## Waste Permits Division Correspondence

Facility Name: City of Uvalde Landfill

Subject: City of Uvalde MSW Landfill - Uvalde County  
Municipal Solid Waste - Permit No. 1725  
Permit Modification Application – Landfill Gas Management Plan – Notice of  
Technical Deficiency  
Tracking No. 31432047; RN102803921 / CN600648455

On behalf of City of Uvalde (City), SCS Engineers (SCS) has prepared the following response to the Texas Commission on Environmental Quality's (TCEQ's) April 28, 2025 Permit Modification Application – Landfill Gas Management Plan – Notice of Technical Deficiency (NOD) email, related to the permit modification to address revisions to Attachment 14 - Landfill Gas Management Plan (LGMP).

DRAWING TITLE	GAS MONITORING FEATURES
LOCATION MAP	
PROJECT TITLE	CITY OF UVALDE LANDFILL
	PERMIT MODIFICATION

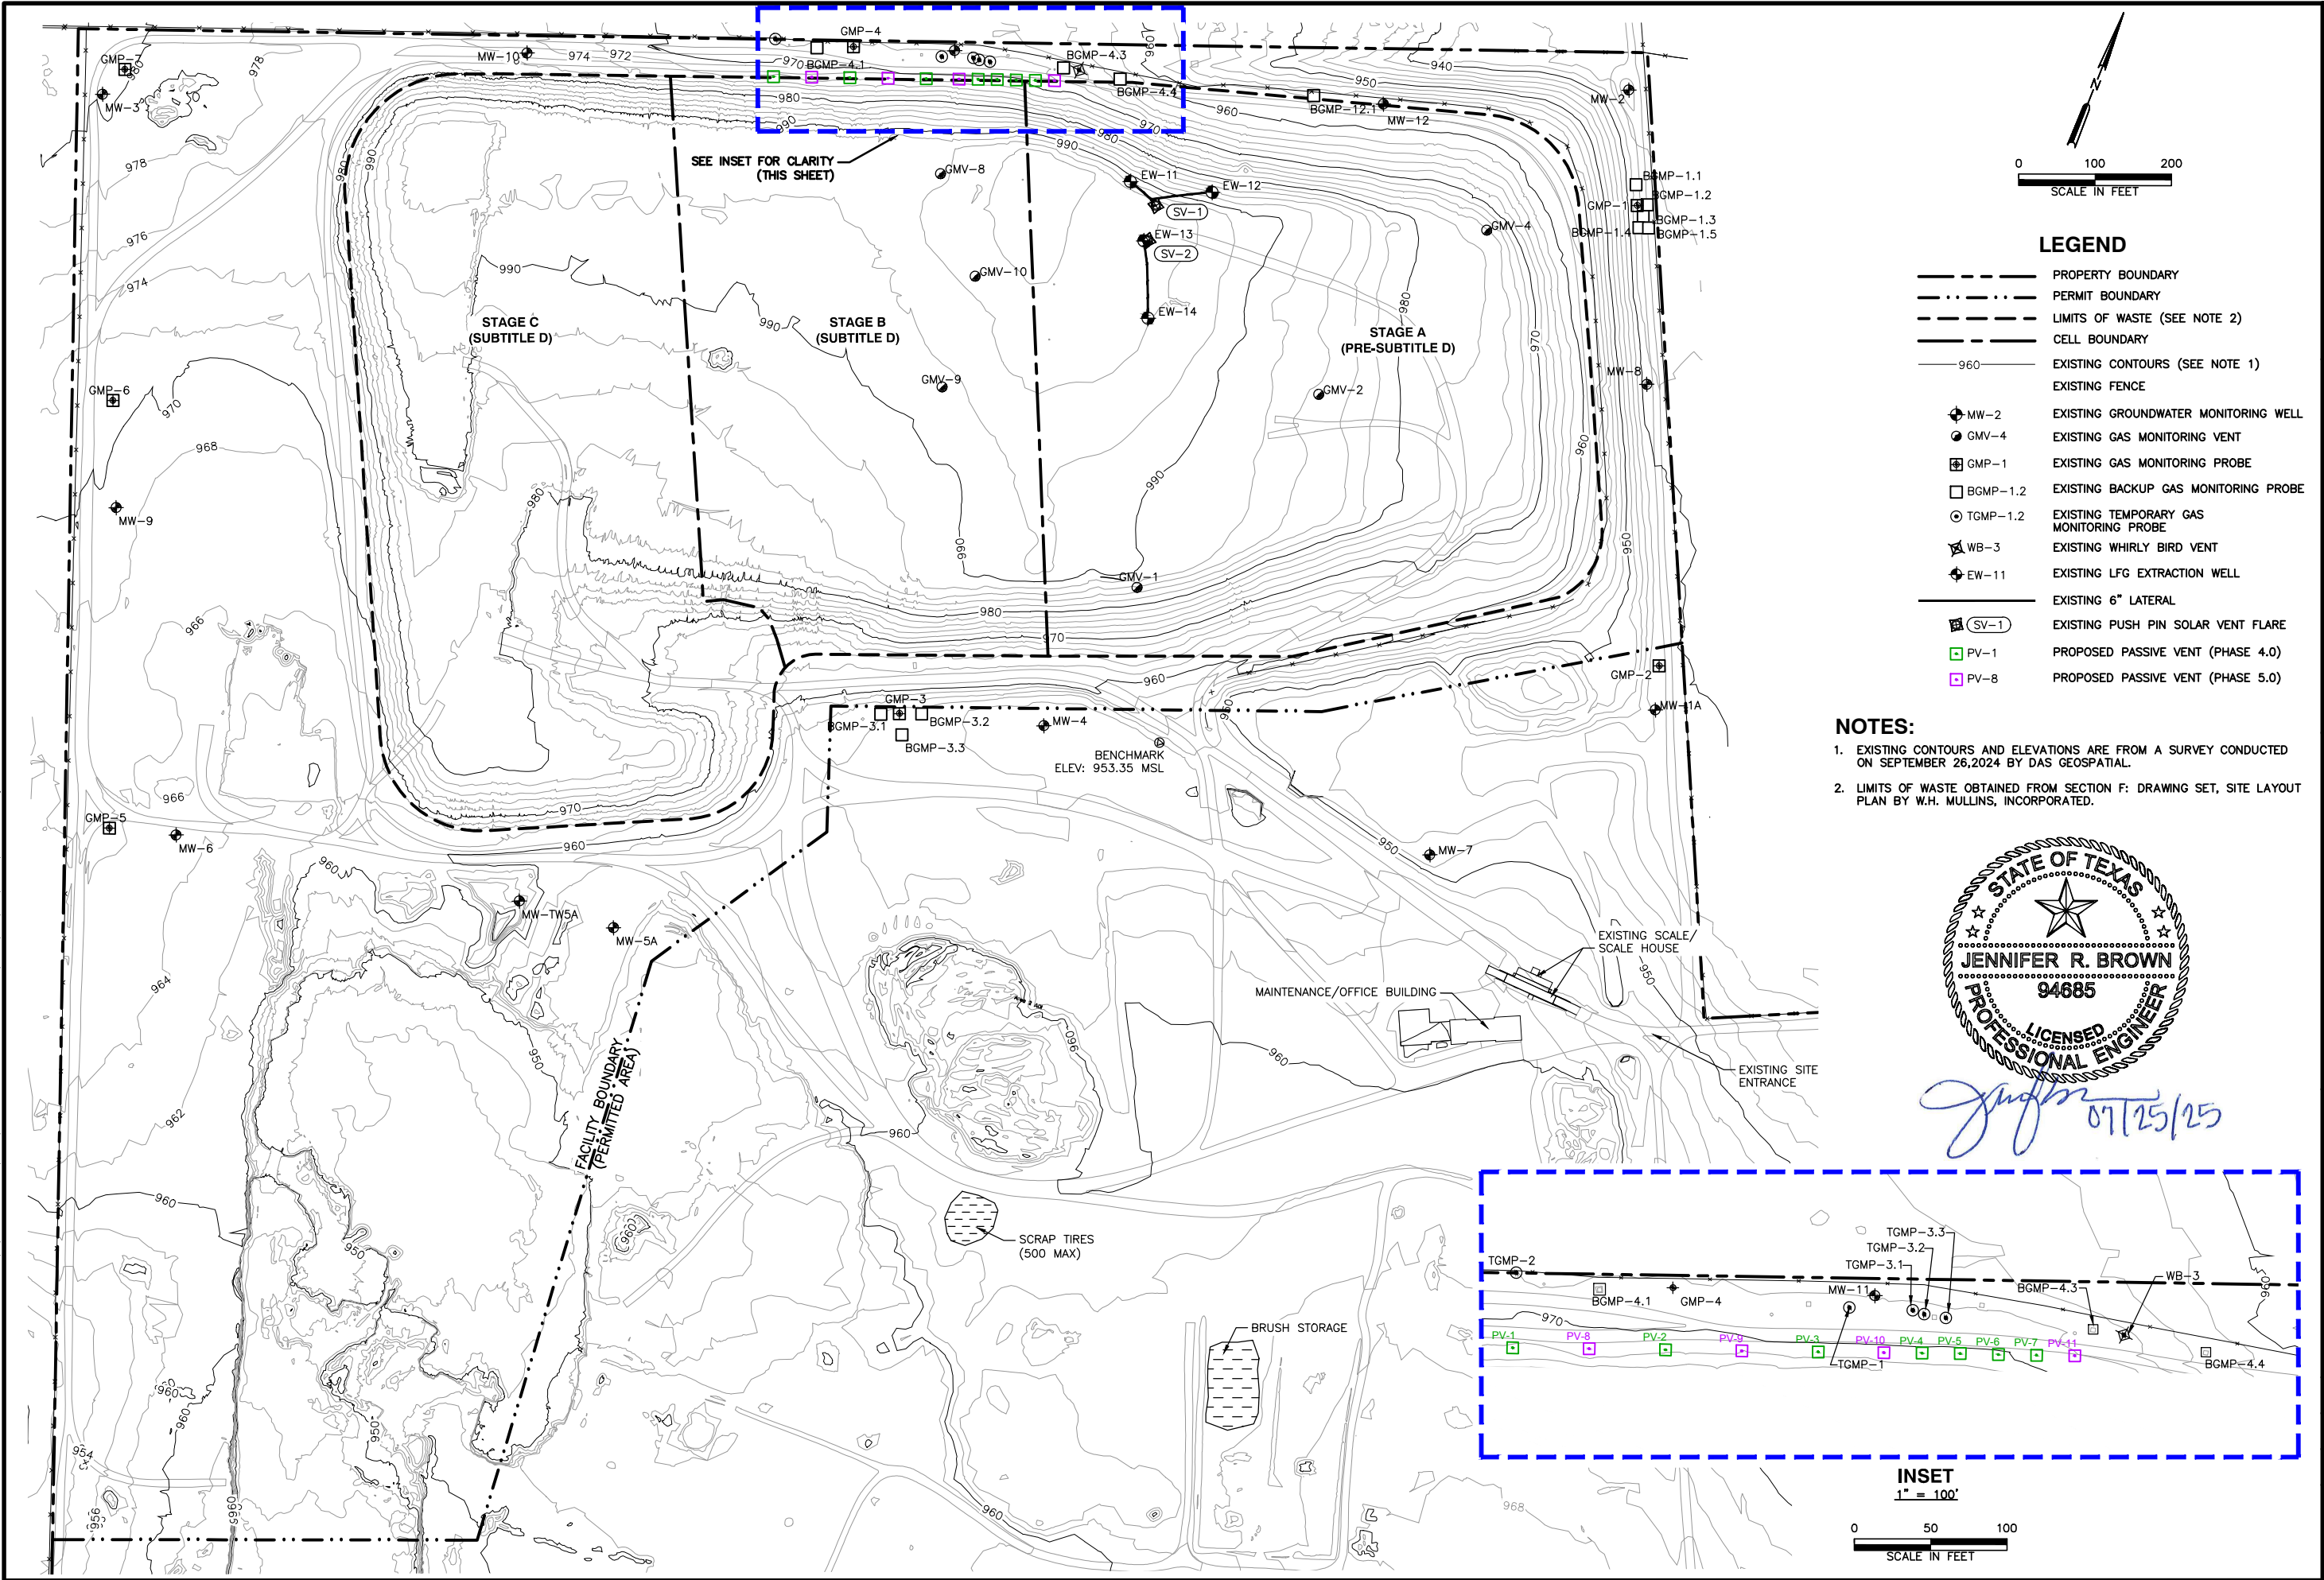
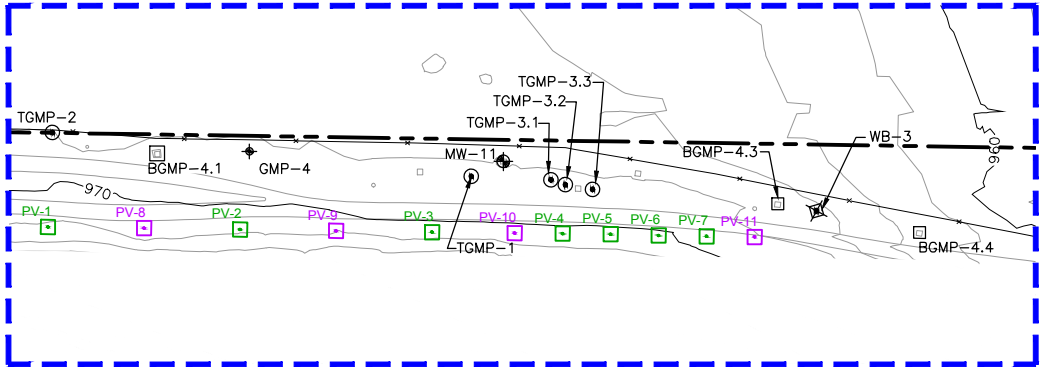
A5a. Figure 3.1, Gas Monitoring Features Location Map

- (i) Review and revise the map to ensure it shows all probes, vents, extraction wells, and other features that currently exist at the facility, and that all are labelled correctly.

- (ii) Add a bar scale to the inset map.

***Part III, Att. 14, Figure 3.1, Page 18: One (1) existing whirly bird vent and proposed Phase 4.0 & 5.0 passive vents from the updated landfill gas remediation plan, dated May 29, 2025, have been added to Figure 3.1. All other current features are shown and labelled correctly.***

***Part III, Att. 14, Figure 3.1, Page 18: A bar scale has been added as requested.***

***Part III, Att. 14, Figure 3.1, page 18, the drawing has been updated to include the updated remediation features described in the LGRP dated May 29, 2025, located in Appendix B.***

REV	DATE	DESCRIPTION	BY
1	07/2025	ADD PASSIVE VENTS, BAR SCALE & SURVEYOR	JRB
2		REMOVE TEMP VENTS & BGMP-4.2	JRB
